# Access Compliance Report

### (Curb Ramps)

| Intersection ID: 52299                  | Main Street: LAKE_VISTA_LN | Cross Street: LINDA_VISTA_LN            | Location: S            |
| ADA ID: B3591E5C6A7E                    | Ramp Type: PerpDiag        | Initial Pass/Fail: Fail                 | Overall Compliance: No |

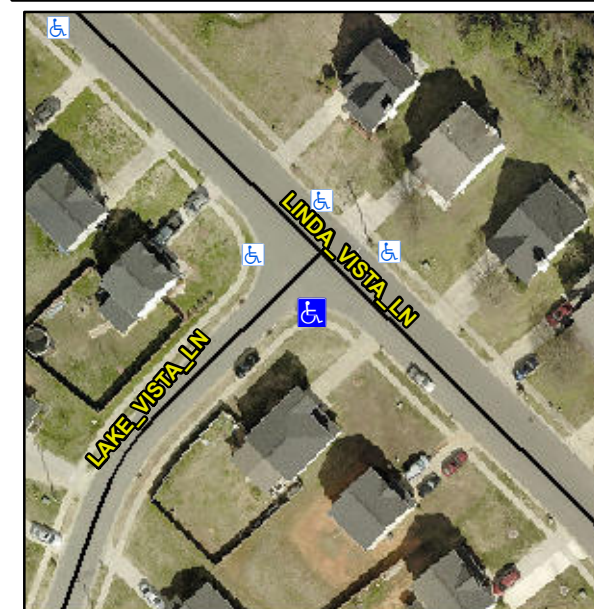
**Not Found, R304.5.1, R304.2.2**

| Compliance | Description           | Data  | Compliance | Description                 | Data  |
|------------|-----------------------|-------|------------|-----------------------------|-------|
| N/A        | Ramp Length (in)      | 48.0  | No         | Ramp Slope (%)              | 10.8  |
| No         | Ramp Width (in)       | 47.0  | Yes        | Ramp XSlope (%)             | 1.0   |

**Remove & Replace Curb Ramp With Two New Directional Ramps or Equivalent.**
